## Broadway and Ogden Lane Improvements

### ADDENDUM 2

March 6, 2026

SHEET  
**C-118**

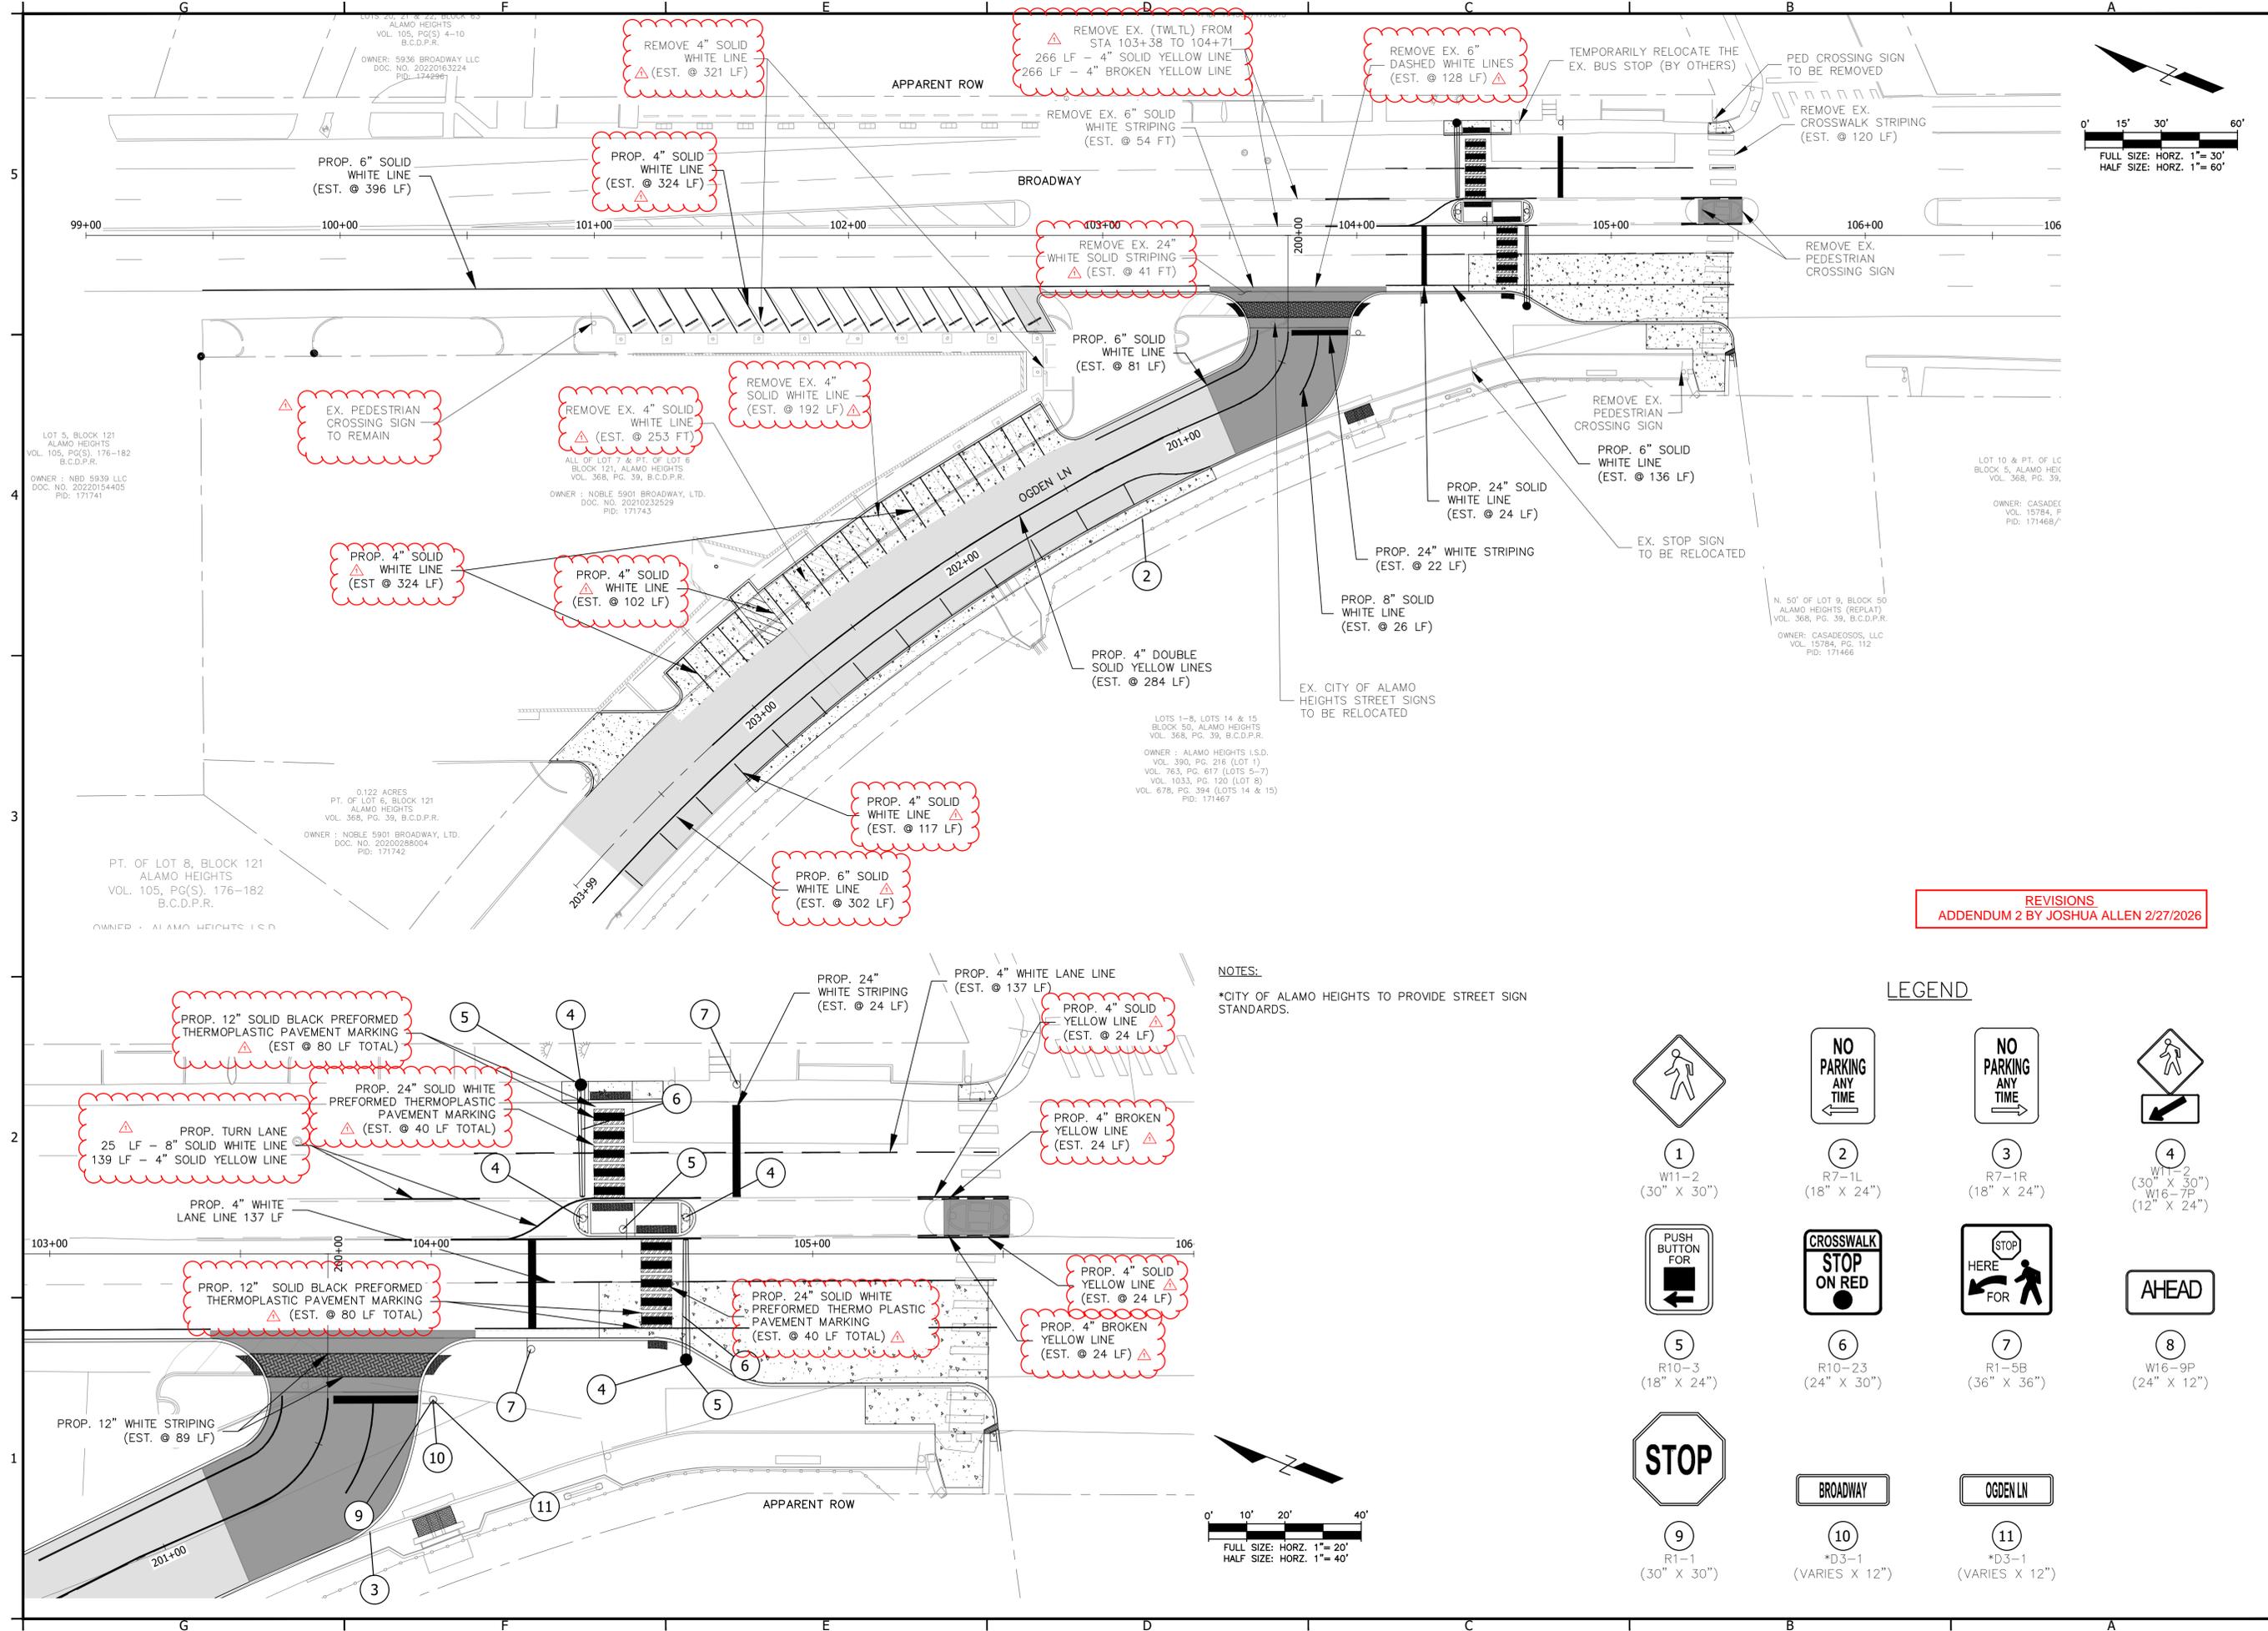
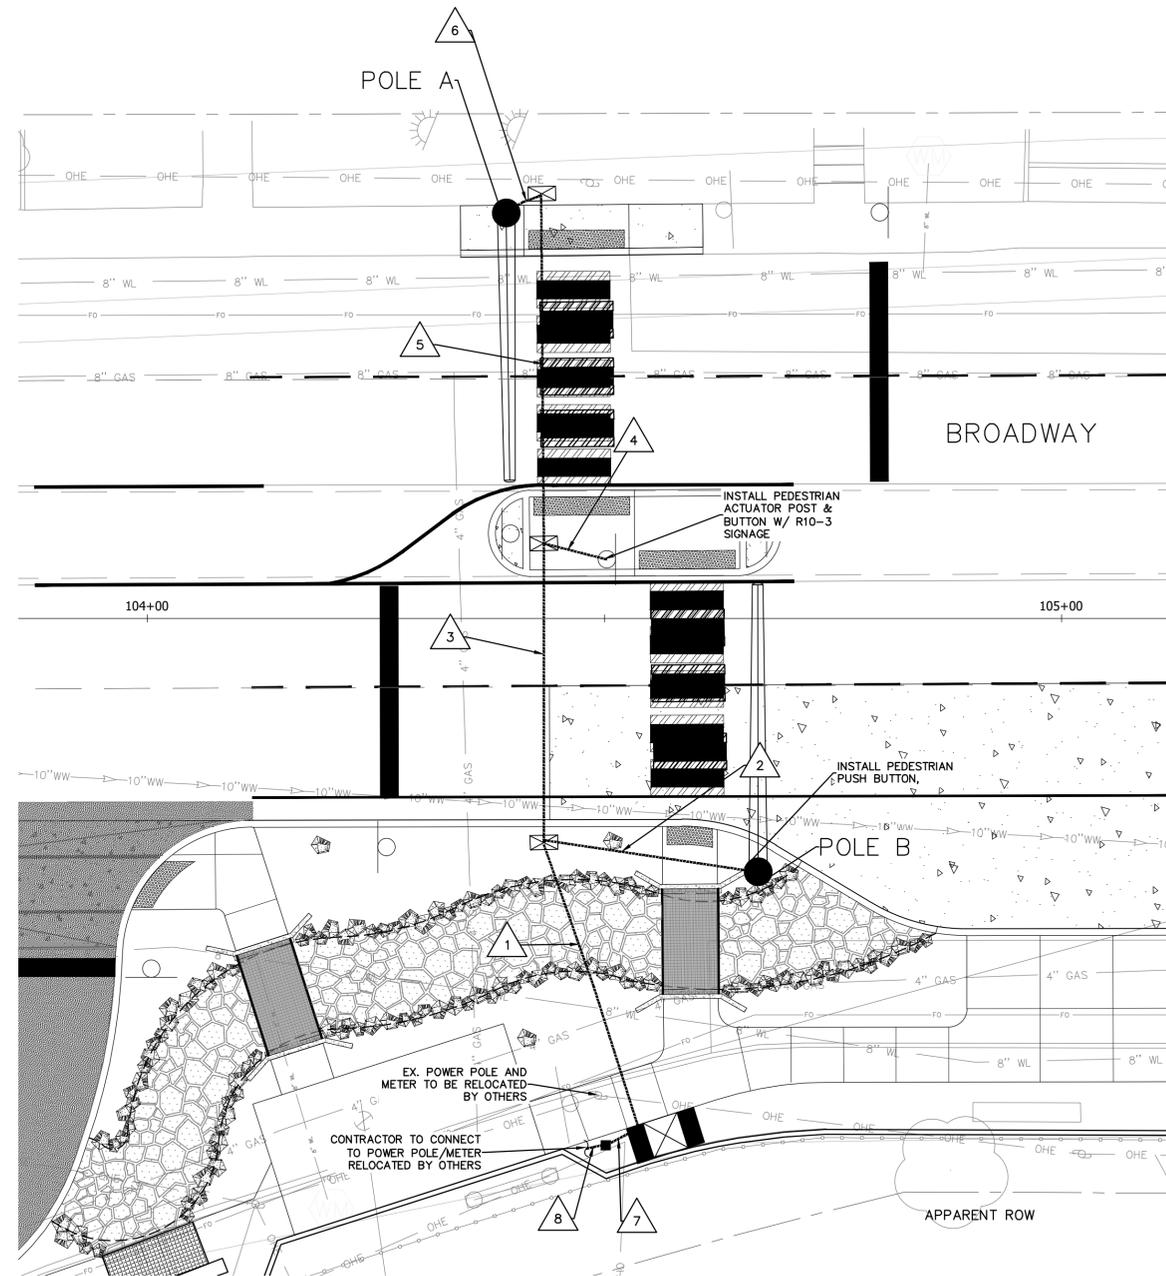
13. **Question:** Bid Item 62 – Install Vehicle Signal Section with back plate (12) shows 12 EA. Drawing C-119 shows pedestrian hybrid beacon signal heads (three-light signal heads). Will these be supplied by the owner?

15. **Question:** Sheet C-119 shows pedestrian countdown modules, but there is no bid item for these.

**Response:** Pedestrian Hybrid Beacon signal equipment shall be provided and installed by the Contractor unless otherwise noted. All signal equipment required for proper PHB operation shall be included in the Contractor's bid.

**Response:** Pedestrian countdown modules are included as part of the pedestrian signal assembly items and do not require a separate bid item. Contractors shall include all necessary pedestrian signal equipment required for a complete installation.

LUMINAIRE ARM

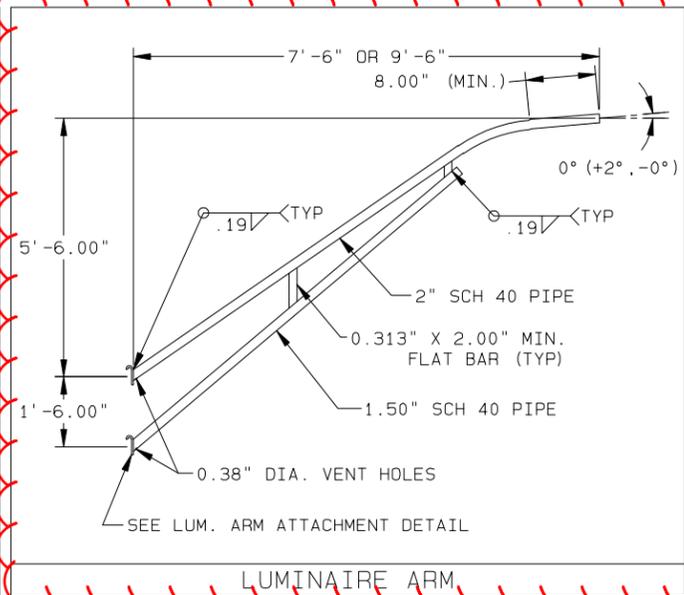
The shop drawings include the luminaire arm detail and pole configuration used for the project (see luminaire arm detail shown in the shop drawing set). These drawings show the typical configuration and connection details for the signal support assembly.
